Subject: VIRGIL C. SUMMER NUCLEAR STATION (VCSNS)  
DOCKET NO. 50/395  
OPERATING LICENSE NO. NPF-12  
RESPONSE TO NRC QUESTIONS REGARDING  
RESPONSE TO GENERIC LETTER 96-06  
(TAC NO. M96872)

**South Carolina Electric & Gas Company (SCE&G)  
Virgil C. Summer Nuclear Station (VCSNS)  
Response to NRC Request for Additional Information (RAI)  
Regarding SCE&G Response to Generic Letter (GL) 96-06**

**Review of GL 96-06 waterhammer condition as it applies to V. C. Summer Nuclear Station**

**FIGURE 1**

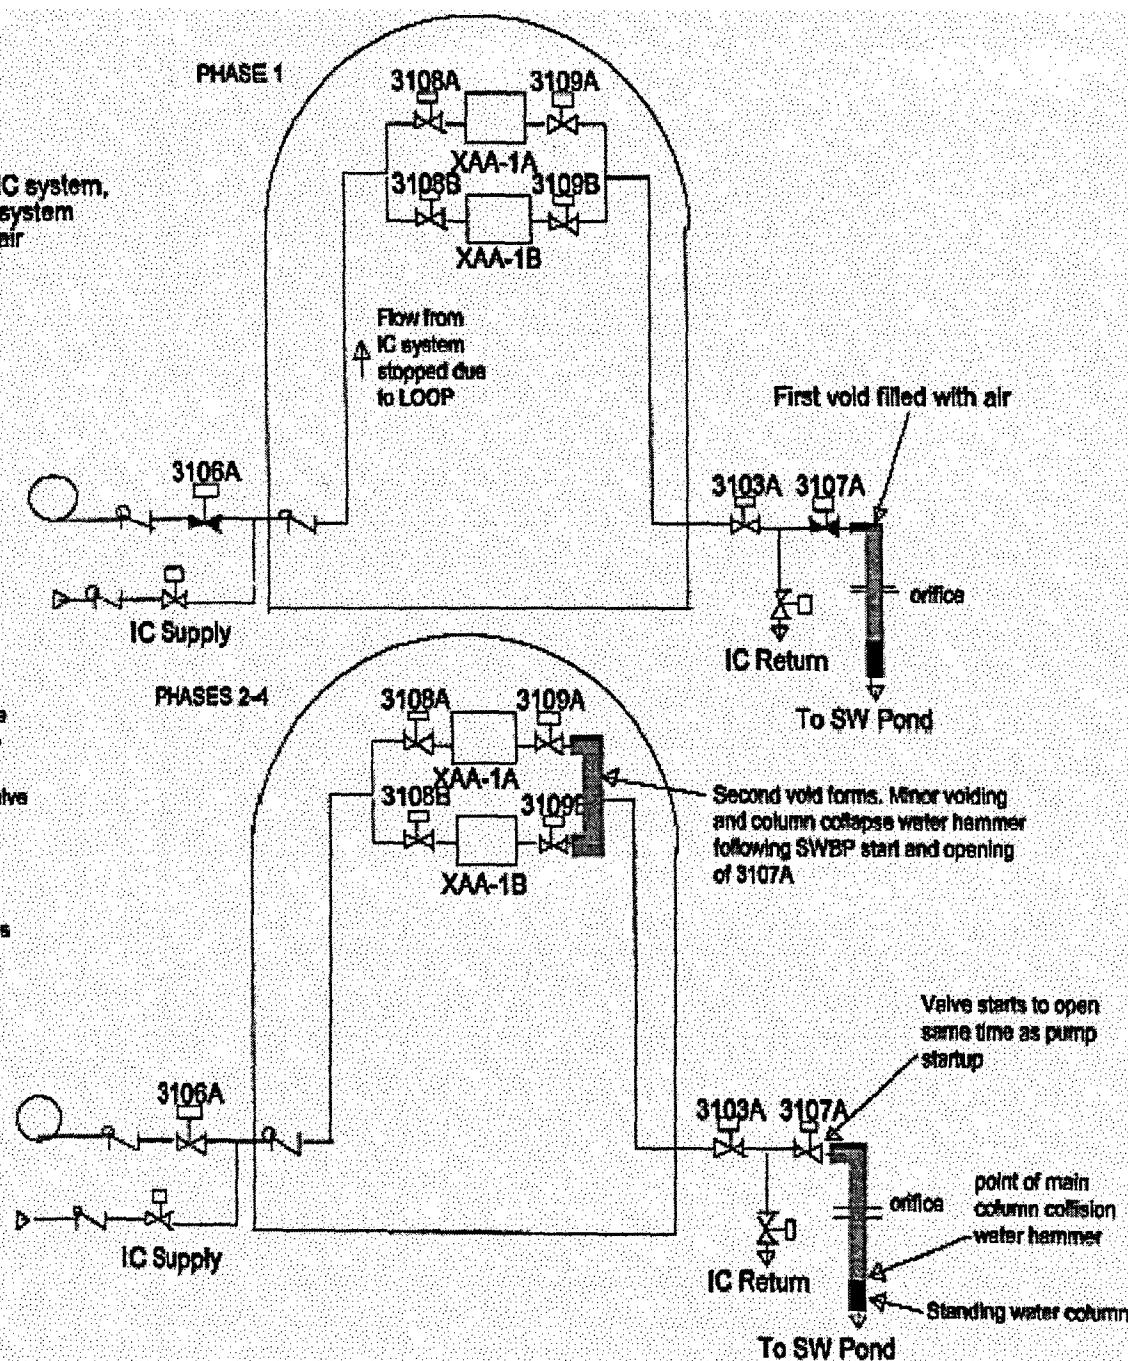
- a. Provide drawings of the service water system showing the location of the injected air pocket relative to the location of the postulated waterhammer. Demonstrate the injected air will flow into any steam space caused by LOOP, LOOP/MSLB or LOOP/LOCA.**

Figure 1 (p.19 of this attachment) shows the locations of the voids and the predicted waterhammer sites for RBCU Train A. Steam voiding in the VCSNS RBCUs does not occur for GL 96-06 scenarios because the fluid pressure in the RBCU coils remains above the saturation pressure corresponding to LOCA peak containment temperature until after SWBP startup.

Following shutdown of SWBP A/B and realignment to IC, a vacuum void forms due to fluid column gravity drainage downstream of valve 3107A/B, the containment isolation valve on the RBCU return piping to the SW pond. Compressed air is injected into the vacuum void by the Operations staff in accordance with plant procedures such that the void is filled with air at a pressure of approximately 1 atmosphere. The air is supplied via a plant air hose (connected only during the fill procedure) and remains trapped between valve 3107A/B and the downstream standing water column until the next time SWBP A/B is started and the associated RBCUs are placed on SW cooling. This relatively large air volume (extending for approximately 119 feet of the 12-inch diameter pipe) cushions the column collapse waterhammer event that analysis predicts could occur following SWBP A/B startup and opening of valve 3107A/B. The waterhammer is projected to occur when the incident water flow from valve 3107A/B reaches the standing water column near flow orifice 99A/B. Figure 1 shows the location of the air volume and column collapse waterhammer locations predicted by analysis.

FIGURE 3

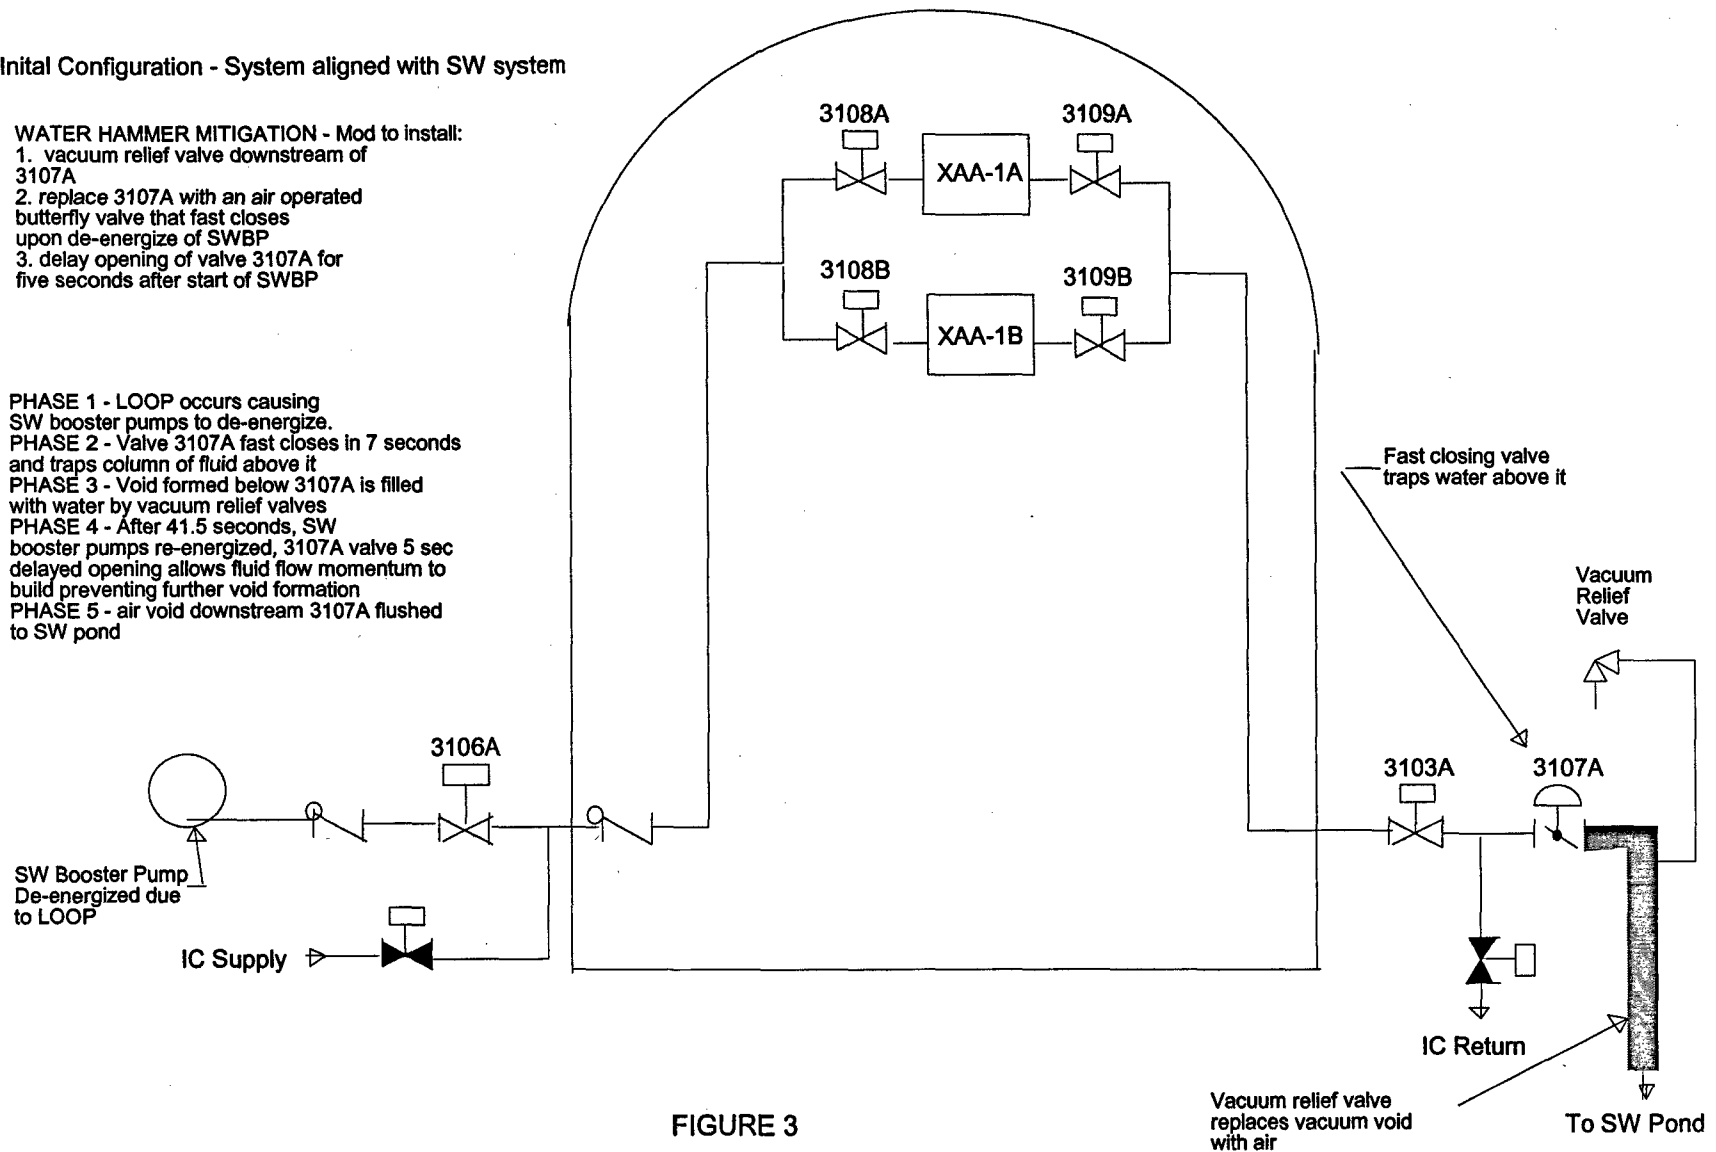
**Explain why the scenario with the safety-related service water system aligned to provide cooling for the RBCUs at the onset of the postulated accident does not result in a more severe waterhammer event, or otherwise establish appropriate restrictions in the Technical Specifications on use of the service water system for RBCU cooling during normal plant operation.**

The second phase requires the implementation of a plant modification in the fall of 2006. This modification will include (Refer to Figure 3, p.34 of this attachment):

- The addition of vacuum relief valves downstream of valve 3107A/B. These valves will replace with air any vacuum void downstream of closed valve 3107A/B that may be formed due to gravity drain-down of water to the SW pond. Upon the opening of valve 3107A/B and the re-start of SWBP A/B, the air in the piping will act as a cushion to minimize any waterhammer affects that could occur at that time. In addition, these relief valves will eliminate the need for operations to manually vent the piping downstream of valve 3107A/B immediately after the transfer of RBCU cooling from the SW system alignment to the IC system as noted in the preceding review discussion and discussed in following question responses.

- The opening logic of valve 3107A/B will be modified to have a 5 seconds delayed opening after SWBP A/B start. The delayed start of the valve opening will assure that additional void formation in the RBCU piping inside containment will not occur upon re-energizing the SWBP.

1. vacuum relief valve downstream of 3107A
2. replace 3107A with an air operated butterfly valve that fast closes upon de-energize of SWBP
3. delay opening of valve 3107A for five seconds after start of SWBP

PHASE 1 - LOOP occurs causing SW booster pumps to de-energize.  
PHASE 2 - Valve 3107A fast closes in 7 seconds and traps column of fluid above it  
PHASE 3 - Void formed below 3107A is filled with water by vacuum relief valves  
PHASE 4 - After 41.5 seconds, SW booster pumps re-energized, 3107A valve 5 sec delayed opening allows fluid flow momentum to build preventing further void formation  
PHASE 5 - air void downstream 3107A flushed to SW pond
